**SUBJECT: Addendum No. 3**

**REFERENCE:** Invitation To Bid (ITB) for Terminal A North (RON) Remain Overnight Parking; Solicitation No. H73-RONADG-2025-001; Project No. PN973

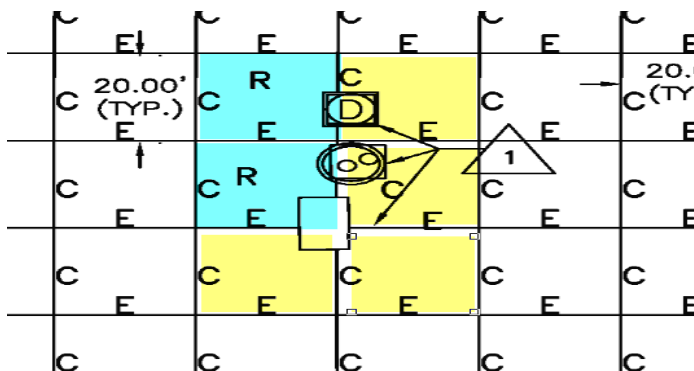
6. **Question:** Reference Addendum 1 Page 9 Subphase 1A Item 4, please confirm that if we perform Phase 1A and 1B concurrently, the durations can be stacked and will be 49 days + 21 days = 70 days.

**Response:** Subphase 1A may be completed at the same time as Subphase 1B or Subphase 1C, but all three Subphases may not be completed at the same time. Subphase 1B may be completed at the same time as Subphase 1A but not also at the same time as Subphase 1C.
